Florida Department of Transportation

ADDENDUM NO. 4

CONTRACT NUMBER: E3U76

DESCRIPTION: Design Build for SR 30 (US 98) Brooks Bridge No. 570034

Figure 3: Lighting Design and Construction – West of Bridges

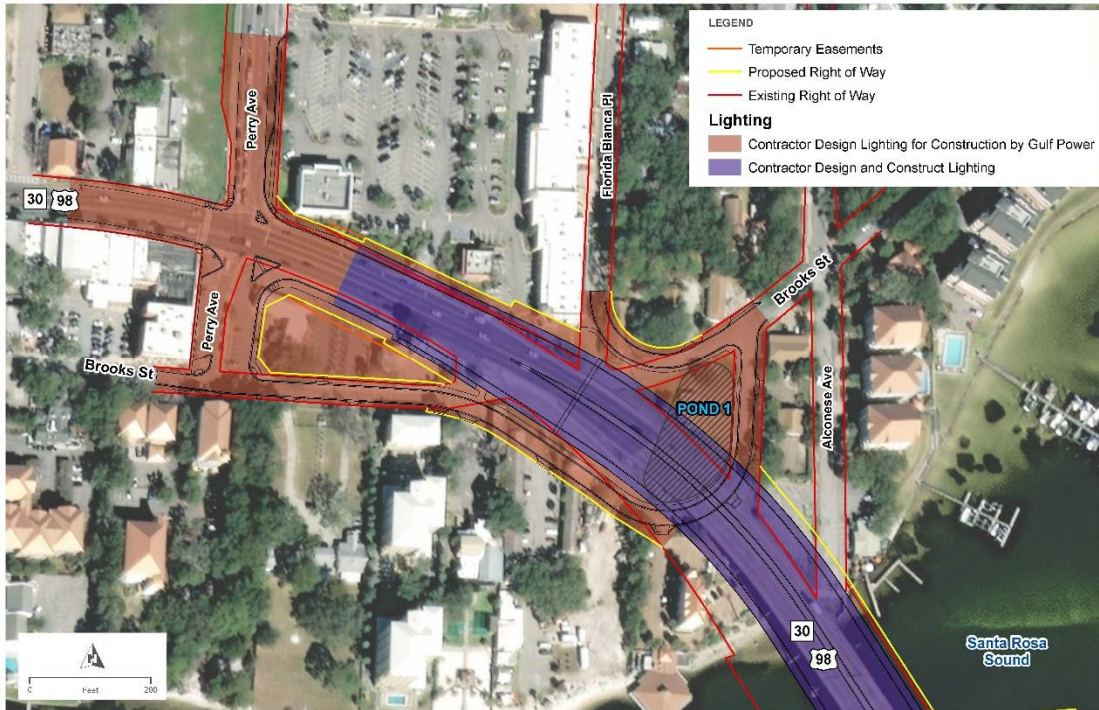
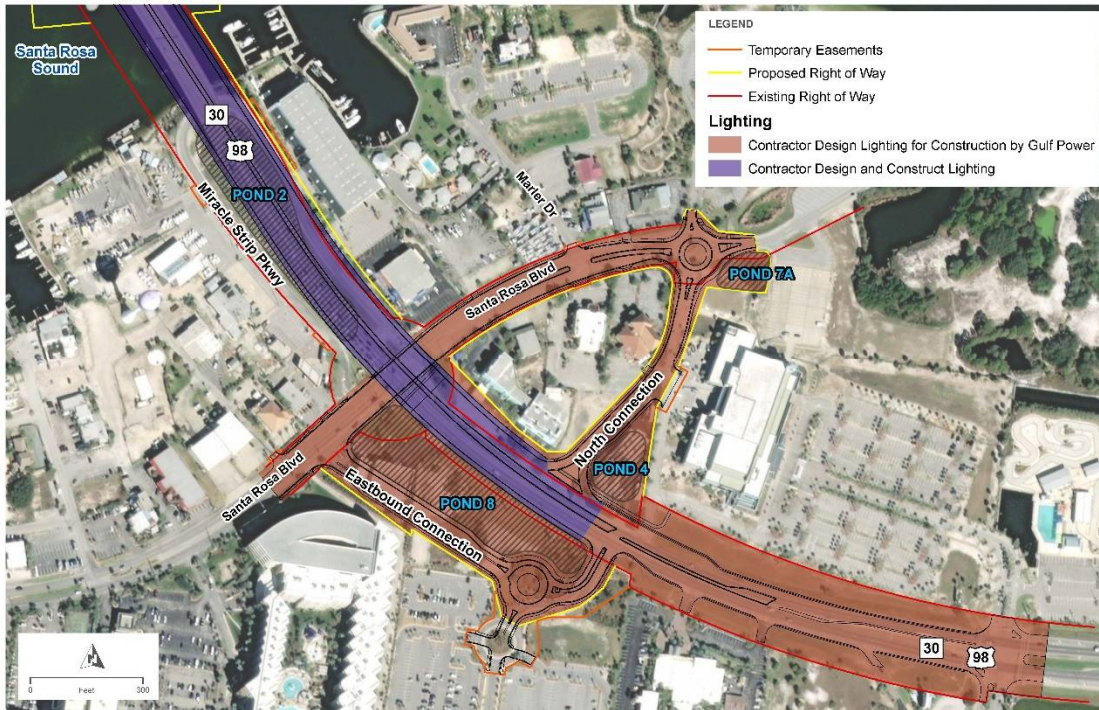
The Design-Build Firm shall design all remaining lighting which will be constructed by Gulf Power. See Figures 3 and 4 below depicting the approximate limits of lighting design and construction west and east of the proposed bridges. There is existing lighting on SR 30, Brooks Street, Florida Blanca Place, and Santa

The existing lighting in conflict with the proposed design shall be removed. **Temporary lighting shall be provided if existing lighting is removed prior to installation of proposed lighting.** The Design-Build Firm shall remove lighting in conflict and stockpile on site for the Department's contamination contractor to remove from the project. Contact the District Contamination Coordinator at (850) 330-1511.
